SUBJECT: SURRY UNITS 1 AND 2 - ISSUANCE OF AMENDMENTS RE: CHEMICAL AND
VOLUME CONTROL SYSTEM AND SAFETY INJECTION SYSTEM
(TAC NOS. M89646 AND M89647)

AMENDMENT NO. 199 TO FACILITY OPERATING LICENSE NO. DPR-32 - SURRY UNIT 1
AMENDMENT NO. 199 TO FACILITY OPERATING LICENSE NO. DPR-37 - SURRY UNIT 2

ATTACHMENT TO LICENSE AMENDMENT

**ALLOWABLE AIR PARTIAL PRESSURE
SURRY POWER STATION UNITS 1 AND 2**

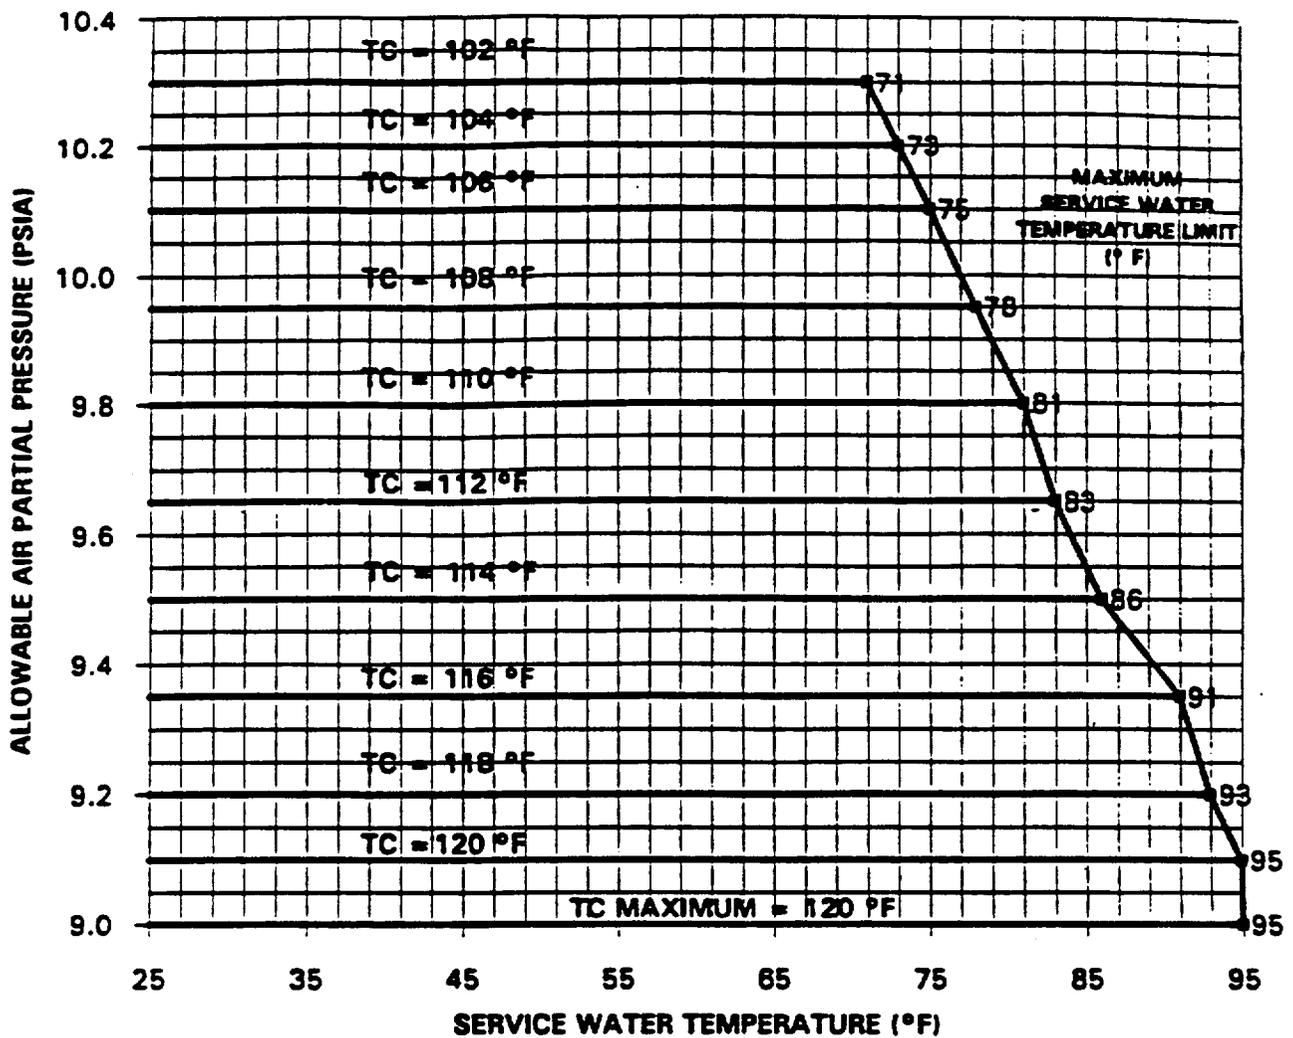
Clarification is made to TS Figure 3.8-1, Figure Notes, Item 1, by adding reference to the 8-hour allowed outage time for conditions where the RWST temperature is not within specified limits.

Clarification is made to TS Figure 3.8-1, Figure Notes, Item 1, by adding reference to the 8-hour allowed outage time for conditions where the RWST temperature is not within specified limits.

1. Refueling Water Storage Tank temperature $\leq 45^{\circ}\text{F}$, with an 8 hour AOT.
2. Allowable operating air partial pressure in the containment is a function of service water temperature.
3. Horizontal lines designate allowable air partial pressure per given containment average temperature.
4. Each containment temperature line is a maximum for the given air partial pressure.
